December 5, 2025
File No. 27224317.00

Subject: Permit Revision Request – Landfill Gas Monitoring Network
Great River Regional Waste Authority Sanitary Landfill
Phase 2 MSWLF Unit
Permit No. 56-SDP-07-80P

Figure 1

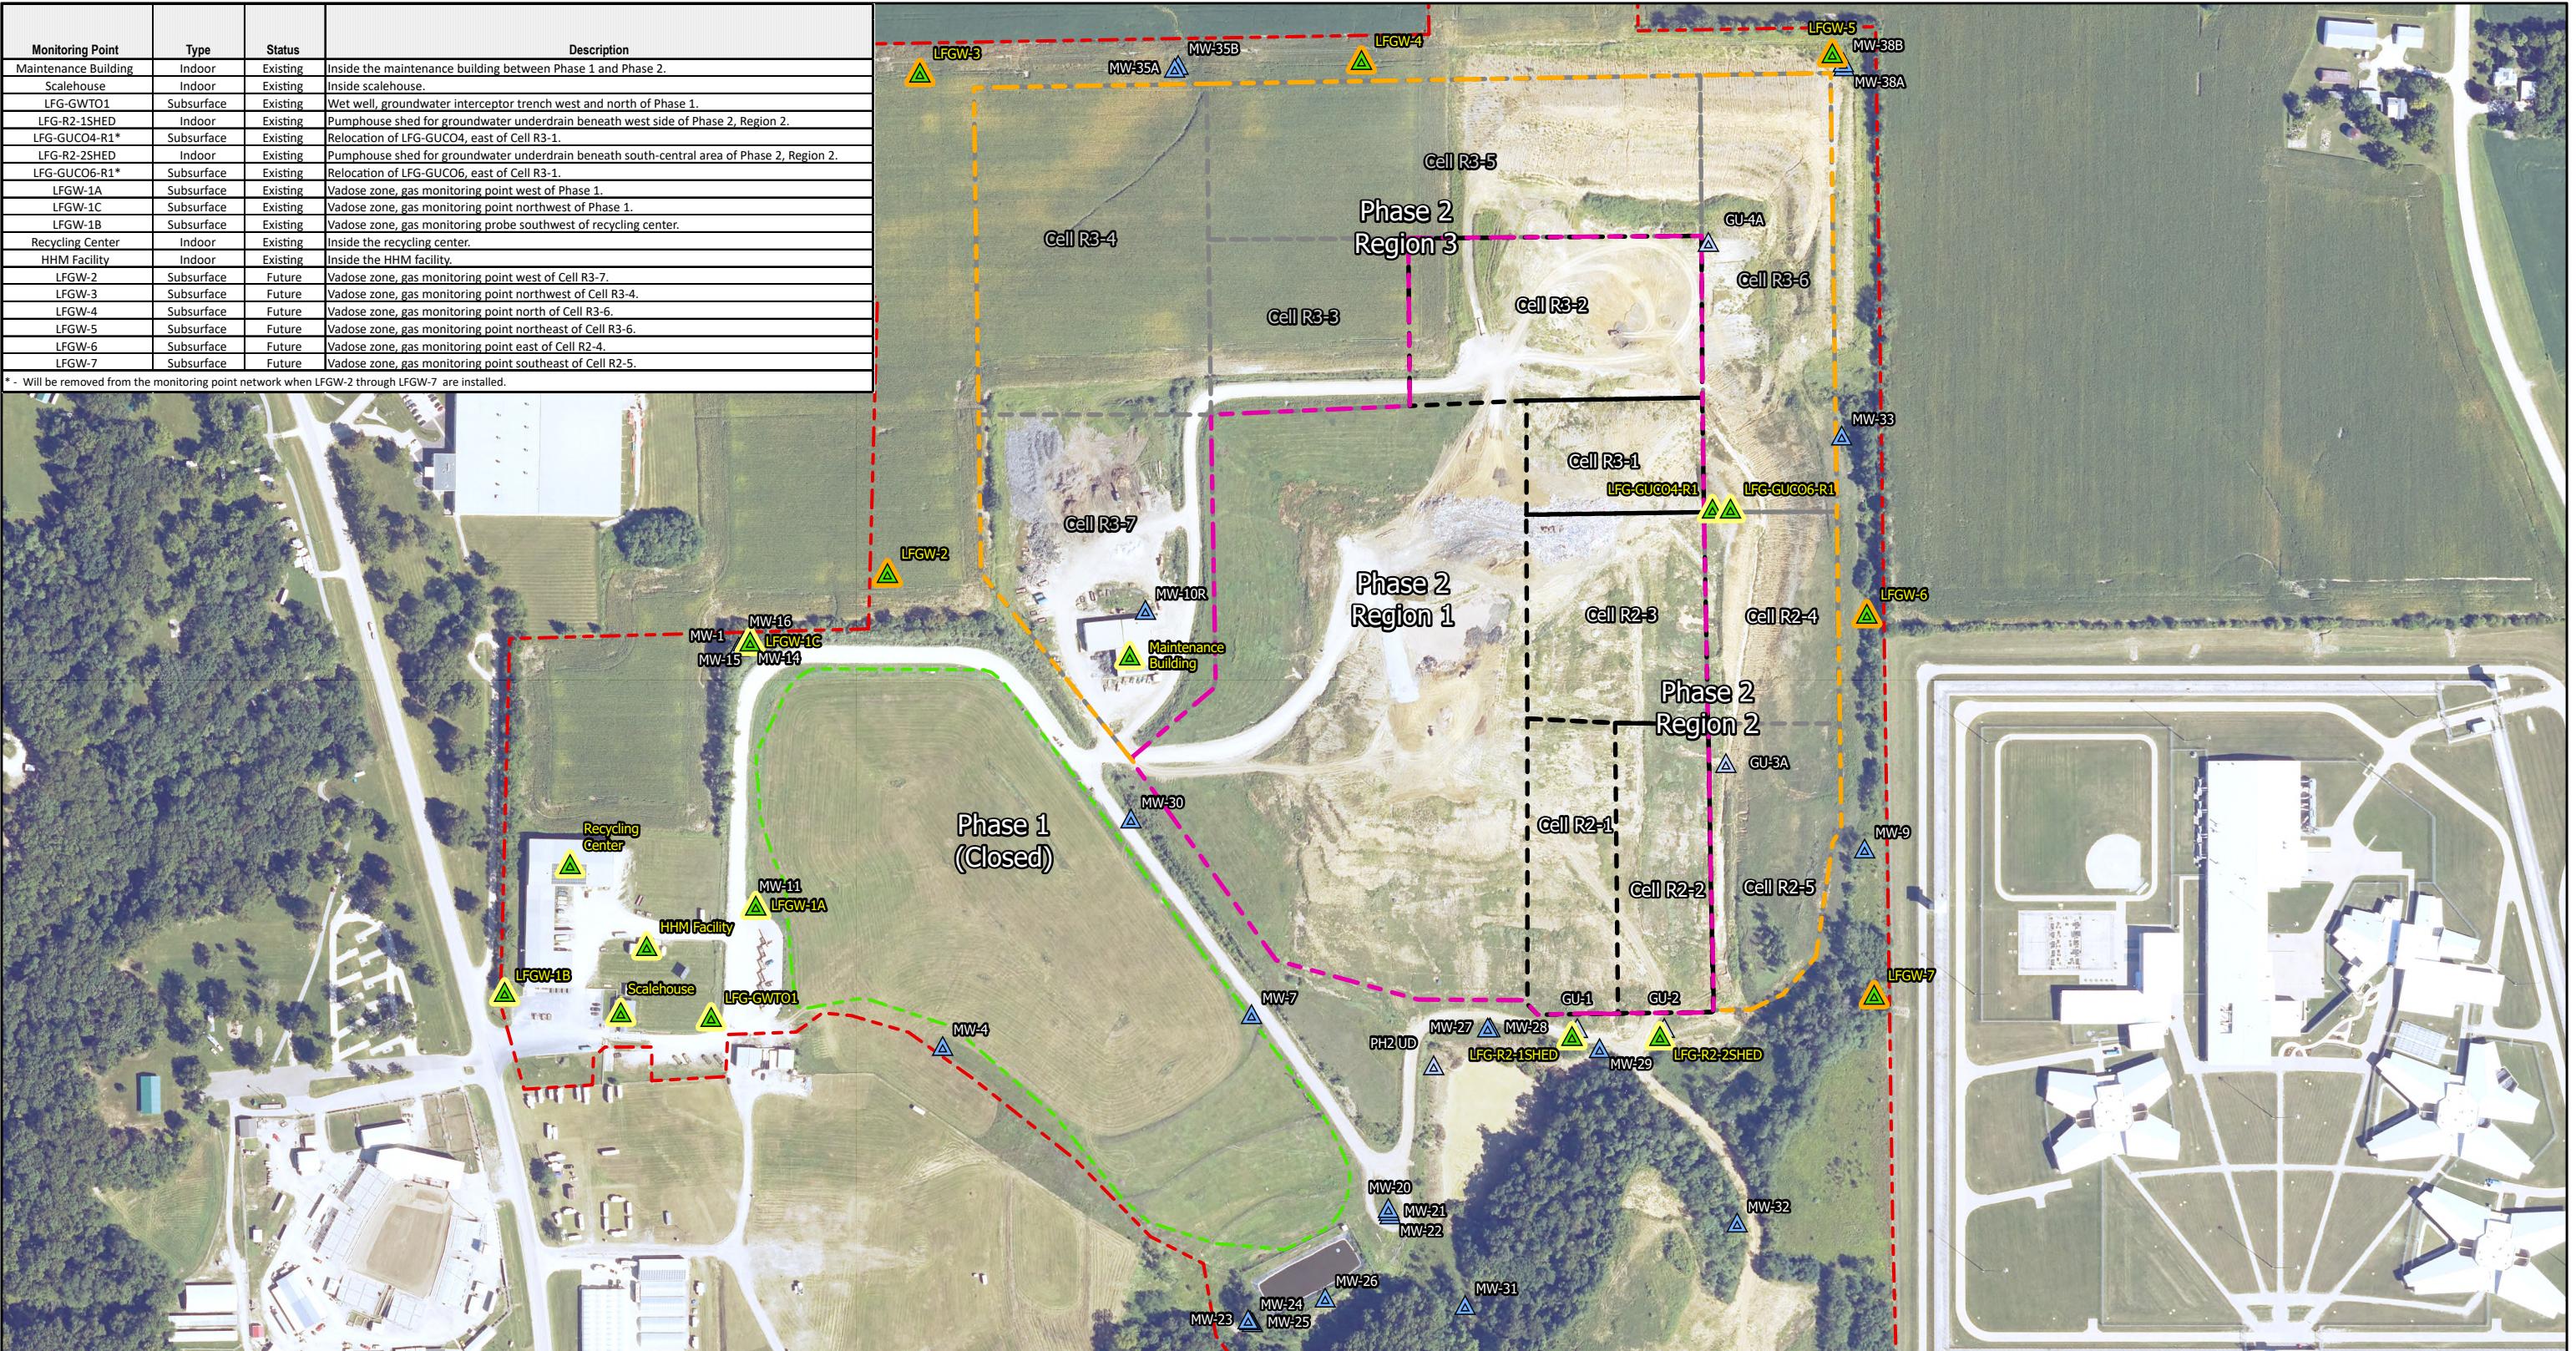
1. Remove future groundwater underdrain monitoring points from the monitoring network.
2. Retain existing groundwater underdrain monitoring points until the proposed subsurface perimeter monitoring probe network has been installed.

3. Remove monitoring well MW-22 from the LFG monitoring program, as MW-22 is a Phase 1 MSWLF unit groundwater monitoring well that will be abandoned.
4. Add three additional subsurface monitoring probes to the previously approved subsurface monitoring probe network. The monitoring probes are located at a nominal approximate 1,000-foot spacing, with some variation based on off-site receptors. The names and proposed locations of some previously approved monitoring probes have changed, as listed below.

- LFGW-2 is unchanged.
 - LFGW-3 moved to the northwest of Cell R3-6.
 - LFGW-4 is a newly proposed monitoring point located north of Cell R3-6.
 - The previous LFGW-4 was renamed to LFGW-5.

- LFGW-6 is a newly proposed monitoring point located east of Cell R2-4.
 - LFGW-7 is a newly proposed monitoring point located southeast of Cell R2-5.

Monitoring probes LFGW-6 and LFGW-7 are near the Iowa State Penitentiary, located to the east of the GRRWA property.

The proposed revised landfill gas monitoring point network is shown in the attached Table A-1 and Figure 1.
